November 9, 2018

RE: Civil Action No. 1:15-cv-00291-WWC: City Beautiful H<sub>2</sub>O Program Plan – Response to EPA Comments

CRW provides the following clarifications to several interpretations of the CBH2OPP expressed in EPA's cover letter.

Attachment Figure 1: CRW's CSO Warning Signs

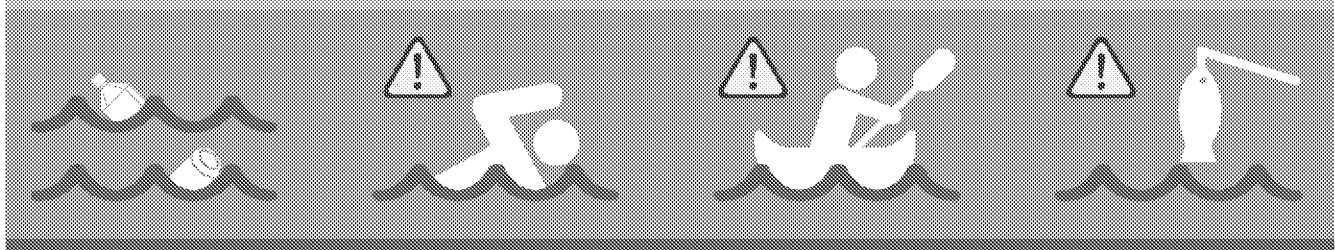
**Comment 2:**

Capital Region Water's CSO warning signs are 36" x 36", more than the minimum size listed in the partial consent decree (24"x18") and are easily read from a reasonable distance. Signs installed in the future will include language indicating that the discharge contains untreated sewage containing harmful bacteria. See Attachment Figure 1 for a full-page example of the 36"x 36" sign.

Attachment Figure 2: Additional Cost Breakdown for Systemwide Control Strategy 2  
Deep Tunnel Storage/Conveyance, Control Point 2

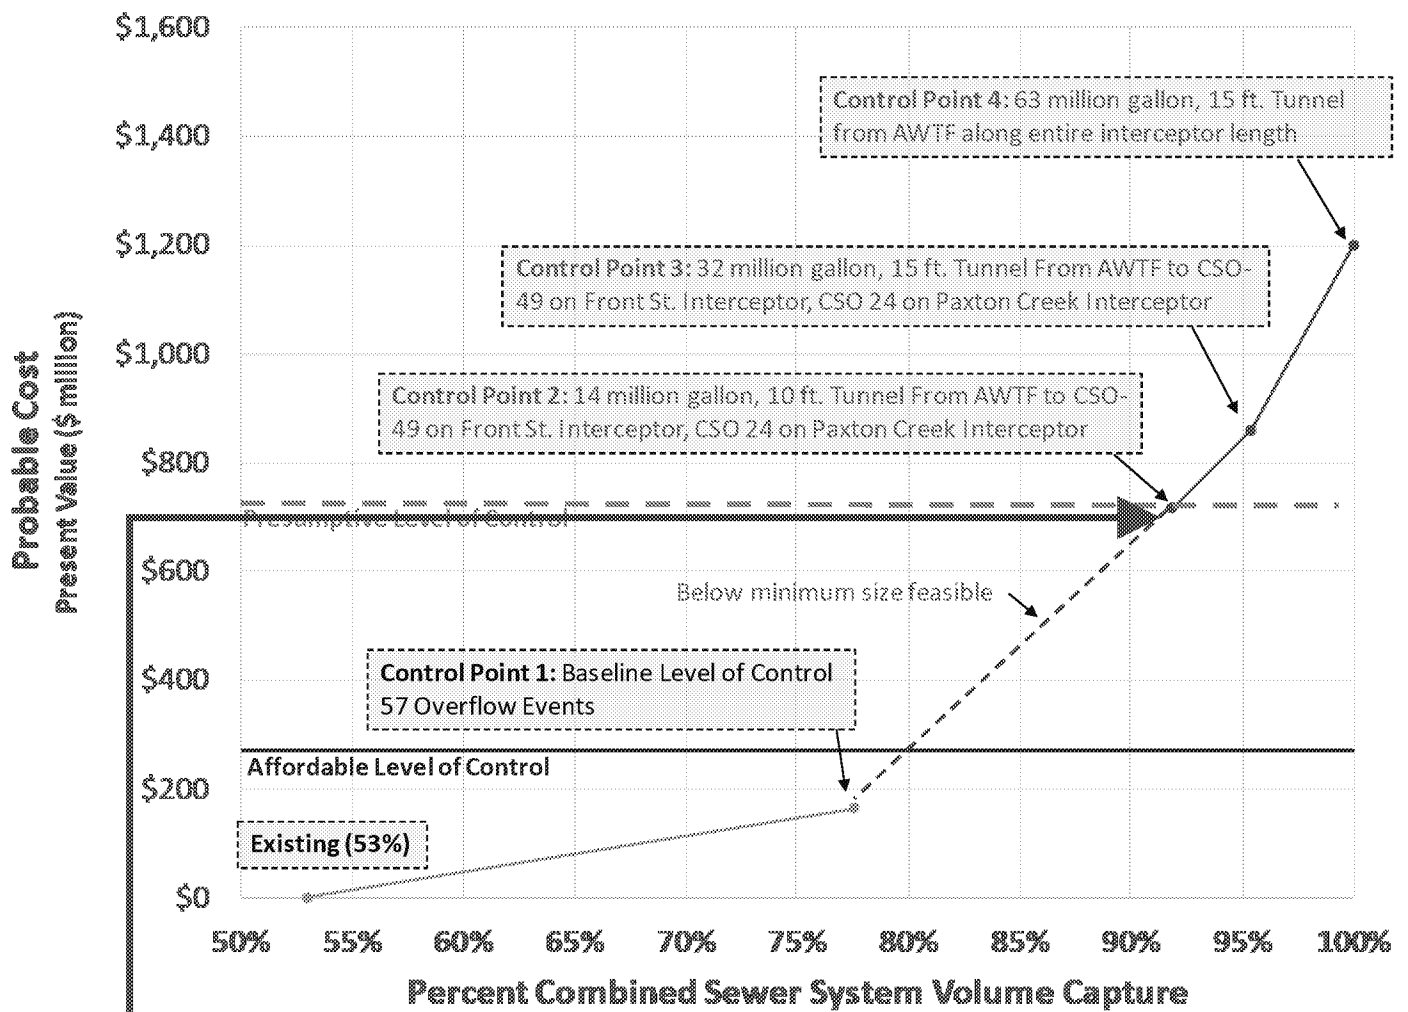
*Section 8 presents cost estimates for both systemwide and Planning Area-specific controls and utilizes those costs to assess the affordability of various LoCs. These costs appear to be based largely upon the City of Philadelphia's 2009 cost document, except for GI costs that were based upon a later Philadelphia document." CRW notes that costs were updated using the Engineering News Record Construction Cost Index and adjusted to the Harrisburg area using the RS Mean factor for Harrisburg. Costs for certain technologies are inflated, for example, storage basins are costed on a per-unit basis. CRW must provide additional detailed breakdowns regarding the systemwide and Planning Area alternatives cost estimates.*

**Response 23:**

Attachment Figure 3: Additional Cost Breakdown for Systemwide Control Strategy 2  
Deep Tunnel Storage/Conveyance, Control Point 3

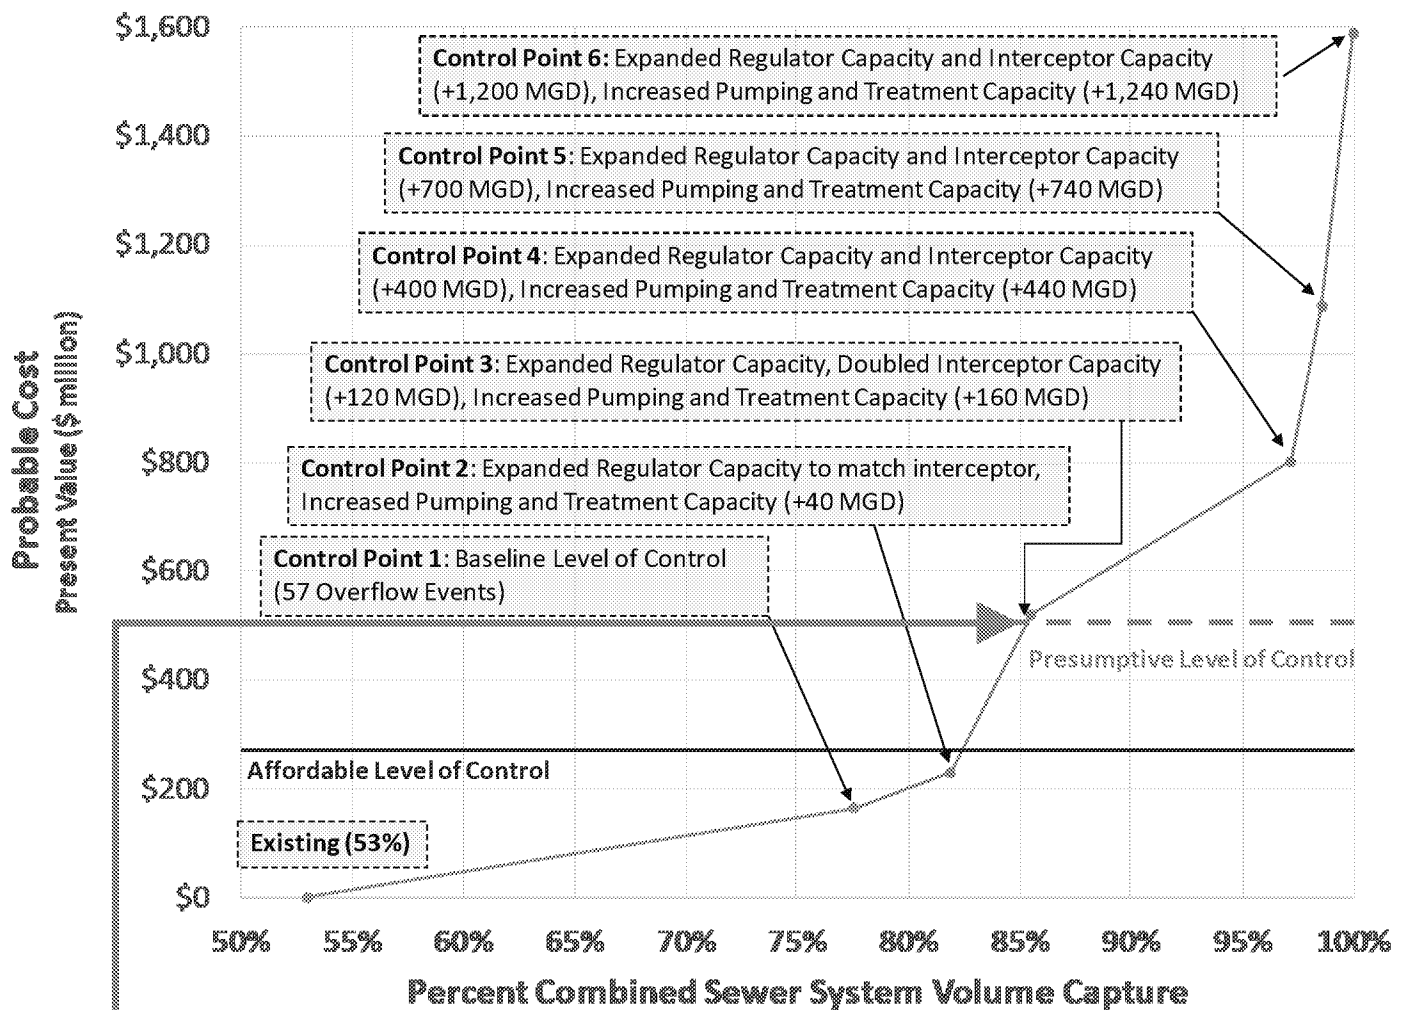
**Comment 24:**

The alternative identified in the comment is comprised of parallel interceptors/conveyance piping, expanded pump stations, and high rate weather treatment at a centralized location. A range of treatment technologies was considered in preparation of the alternative, but it was found that the conveyance of wet weather flows to a centralized treatment facility (at the AWTF or similar location) was the significant cost driver – nearly 90% of the alternative cost (outside of baseline system

improvements). More detailed cost estimates for this alternative are provided (see Attachment Figure 3).

Attachment Figure 5: Spring Creek Pump Station Typical Year Peak Flow Event Hydrograph

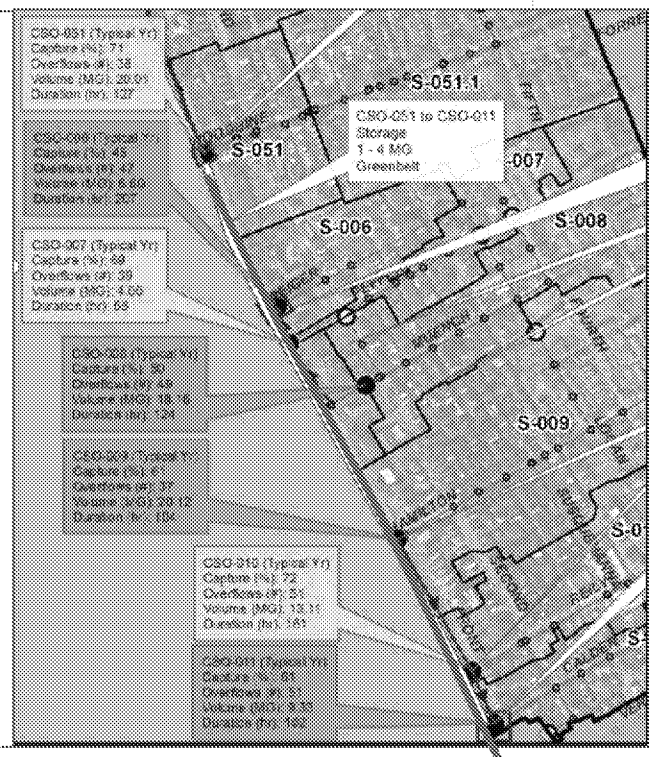
- f) *Section 8.4.15 discusses the separate Spring Creek Planning Area. The Plan notes that "approximately 94% of the tributary area and over 90% of the dry and wet weather flows into and through CRW's Spring Creek Interceptor" are generated by CRW's wholesale customers. The Plan notes that both the Spring Creek Interceptor capacity and Spring Creek Pump Station capacity are exceeded in the 2-year storm event and that SSOs are predicted to occur. CRW must provide additional information regarding the magnitude of the flows from this interceptor during the typical year to provide a better understanding of the degree to which wet weather flows from the wholesale customers impact the combined sewer system's typical year performance.*

Wholesale customer flow during wet weather periods is up to 80% of the wet weather volume discharged from the Spring Creek pump station to the AWTF, however the planned Spring Creek

Pump Station capacity is greater than the sum of the incoming peak flows from the Spring Creek Interceptor and the Hemlock Creek Interceptor during the typical year. Attachment Figure 5 provides hydrographs of the incoming flows (Hemlock Street Interceptor and Spring Creek Interceptor) to the Spring Creek Pump Station and outgoing flow from the Spring Creek Pump Station for the typical year peak flow event from Spring Creek Pump Station. This event figure shows the sum of the incoming flows (Hemlock Street Interceptor and Spring Creek Interceptor Wholesale and CRW inflows) and the outflow (Spring Creek Pump Station) do not exceed the pump station capacity during this event. The examples suggest that Spring Creek Interceptor is not limiting capture of combined sewage from the Hemlock Creek Interceptor and through the Spring Creek Pump Station, rather Hemlock Street Interceptor system combined sewer flows to the pump station are limited by the hydraulic capacity of the regulator connections and interceptor. However, it should be noted the baseline level of control for the Hemlock Street Interceptor system provides 85% capture of combined sewage volume for this portion of the combined sewer system.
